**Re: Pio Pico Energy Center (11-AFC-01)
Applicant's Additional Responses to Staff's Informal Data Requests
Regarding Biological Resources**

**PIO PICO ENERGY CENTER PROJECT
11-AFC-01**

**Supplemental Responses to Biological Resources Data Requests
Responses to Verbal/Email Request from Ann Crisp, Dated November 8, 2011**

**EXHIBIT A
TRANSMISSION ROUTES**

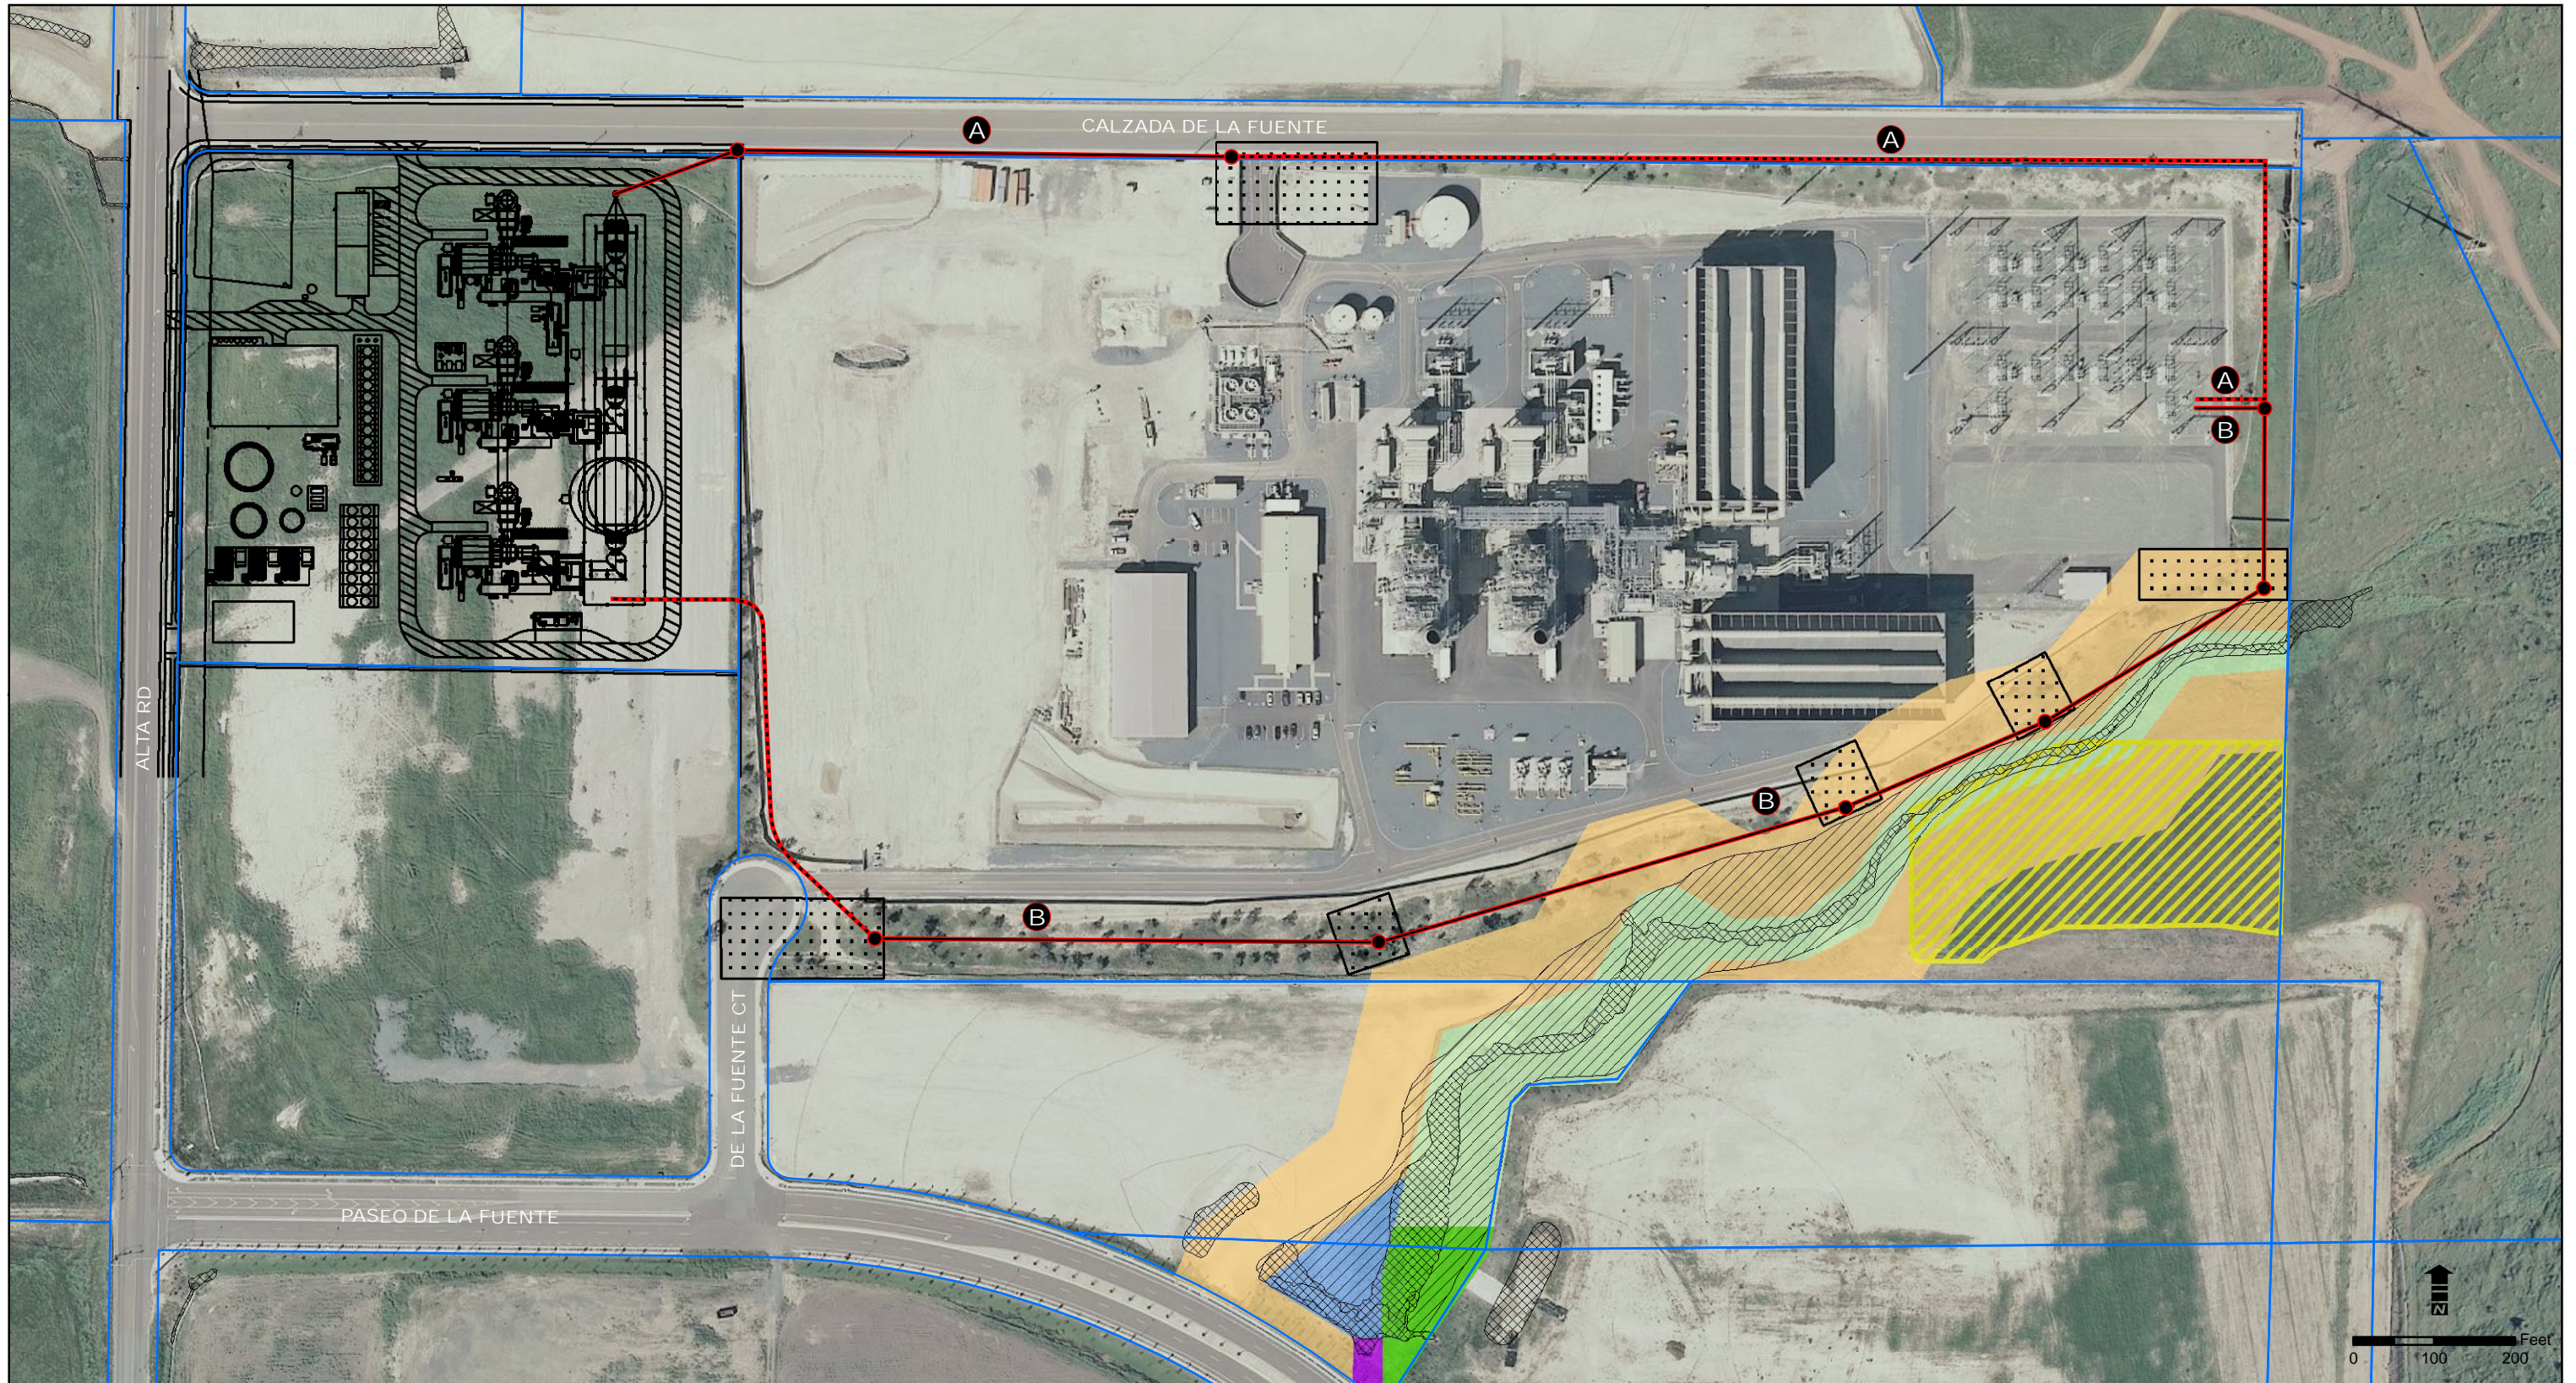
1. This is sent as a follow up to the conference call this afternoon regarding clarification of what was expected to be submitted in relation to the proposed transmission line routes. Please find attached the recorded easements from the County of San Diego that relate to biological resources. The recorded easements attached describe all the covenants terms, conditions, and restrictions placed on several of the easements included on PM 20473, specifically those related to biological resources. These include restrictions on any ground disturbance including but not limited to clearing of vegetation, construction, and vehicular activity. I have included the original email chain from Dave Jenkins regarding the expected scope of the map to be submitted as previously discussed. To clarify, in order for staff to prepare the staff assessment and any conditions of certification related to the installation of the transmission line I will need the following:

1. Detailed site plan map based on PM 20473 (used as basemap) that depicts for both Transmission Line Route A and Route B (two routes total) the following: transmission line route, all pole locations, right of way, and construction staging and access areas (for construction, operation, and maintenance), and all areas to be avoided.
2. Project description which describes how construction, operation, and maintenance of the transmission line will not result in impacts to any recorded easements depicted on PM 20473

The submittal should provide a detailed description of how all activities related to the construction, operation, and maintenance of the project will avoid any impacts to any areas recorded as easements, based on PM 20473. If you have any questions please let me know.

1. Refer to the attached Exhibit A – Transmission Routes showing the recorded County easements provided in Exhibit B - PM 20473. Except for the Fire Buffer easement, the depicted County easements will be avoided during construction and maintenance. (See Exhibit C for an email exchange with the SDCRFD consultant on the Fire Buffer exception.) Exhibit A is also overlaid by the detailed site plan depicting Transmission Line Route A and Route B routes, pole locations, rights of way, and access areas necessary for construction, operation, and maintenance of the proposed transmission facilities. After installation activities are complete, the conductors will be fully contained within the proposed right-of-way and will not impact any adjacent facilities.

2. The following describes Route A and Route B construction, operation, and maintenance activities.

As a result, the Route B transmission line construction and maintenance activities avoid the County easements for archaeological conservation, biological and open space conservation, and drainage areas. Federal and state jurisdictional drainage areas would likewise be avoided.

An approximately 1500 foot portion of the Transmission Line Route A alternative would be placed underground to interconnect at the SDG&E Otay Substation end (refer to Exhibit A). An approximately 700 foot portion of the Transmission Line Route B alternative would be placed underground to interconnect at the Pio Pico facility end (refer to Exhibit A). Any underground segments would be installed either as direct buried in a trench or in duct bank. Trench for direct buried installation would be approximately 2 feet wide by 6 feet deep. Conductors would be buried at a depth of approximately 3 to 6 feet and encased in thermal concrete for heat dissipation. The thermal concrete above the conductors would extend to within 12 inches of the ground surface. Duct bank installation would consist of polyvinyl chloride (PVC) conduits laid side to side and encased in thermal concrete, buried approximately 5 feet deep. Duct bank would have approximately 3 to 4 feet of cover from the ground surface to the duct bank top of concrete. Duct bank installation may require a slope cut back for installation, resulting in an approximately 25' wide disturbance area. Since underground segments would not require a splicing location, underground concrete vaults would not be required. Underground to above ground transition stations (risers) would be installed where the transmission line transitions from below ground to aboveground. Excess fill from any excavations would be hauled back to the Project site and used as fill on the Project site.

EASEMENT DETAIL SHEET

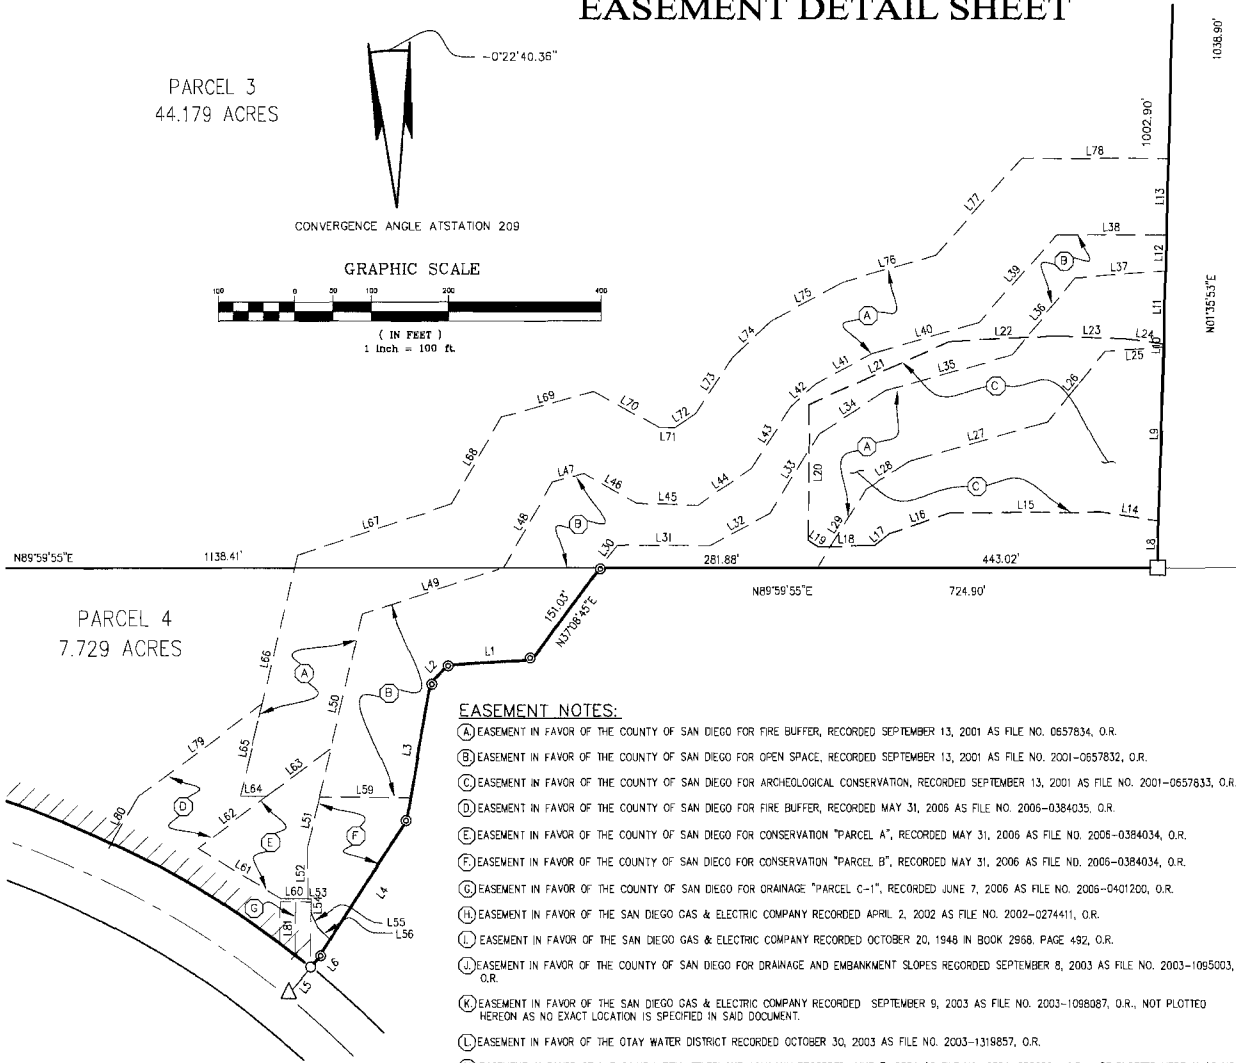
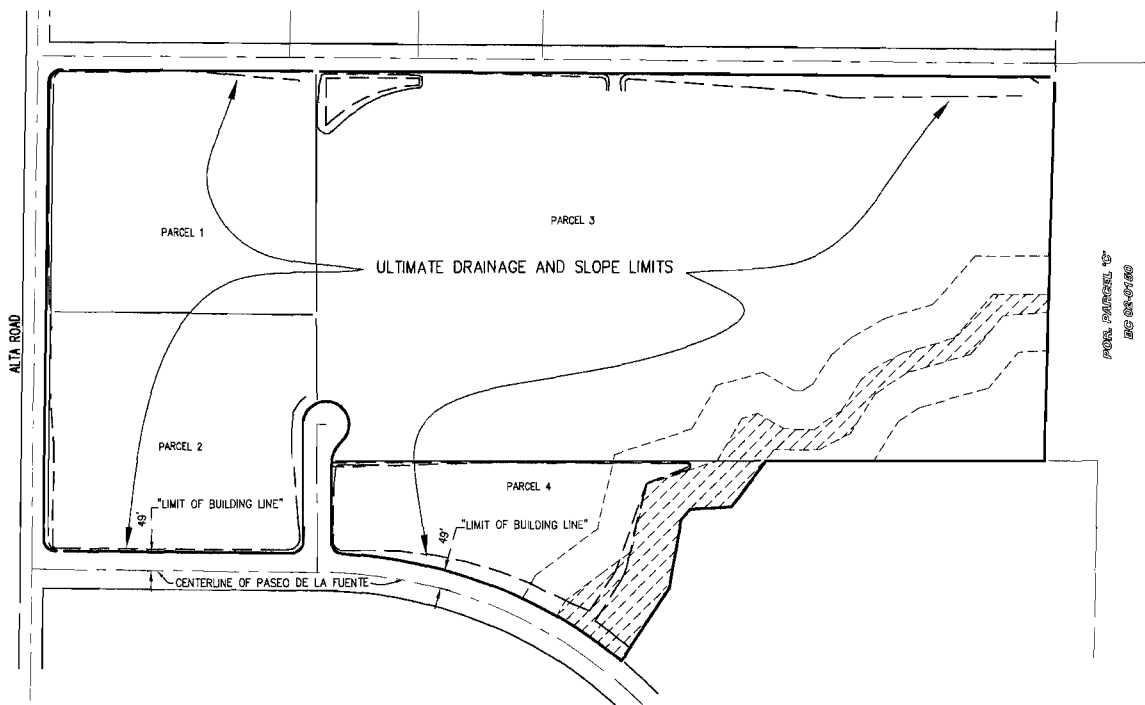
Could you please provide clarification on where the Transmission Line Route B poles and right of way will be located in relation the MSCP designations on the attached map? Also, clarify if Route A was implemented instead where would it be located in relation to the MSCP designations? This map was provided by MSCP

staff and the brown area is considered take authorized under MSCP, meaning it already went through the minor amendment process and impacts are allowed. The area in gray is a recorded biological open space according to the Parcel Map 20473, if impacts are proposed within that area it would require an open space vacation.

Please provide specific information regarding where the poles will be located as it relates to the MSCP designations on the attached map, how and where they will be accessed for installation and maintenance, including any access roads whether temporary or permanent, where any staging areas will be located, and where the 80 foot right-of way is proposed.

As we discussed today, PPEC will construct and maintain the transmission line (A or B) in a manner that will not cause any ground disturbance to MSCP sensitive areas. Furthermore, the line will be designed and located so that construction and operation of the line will not disturb Easements A, B or C as delineated on the County TPM 20473. I will direct the project engineer (Kiewit) to produce a figure based on the TPM that shows the pole locations, R/W and construction staging/access areas to this effect. For now, generally, the installation of Route B poles will utilize access from Paseo de la Fuente and the SDG&E substation. The conductors that span the MSCP sensitive area will be installed via helicopter to avoid ground disturbance of this area. Route A poles will be accessed via Calzada de la Fuente. The underground portion of Route A will be accessed by Calzada de la Fuente to the north, and the SDG&E substation from the south, thereby avoiding ground disturbance of MSCP sensitive areas.
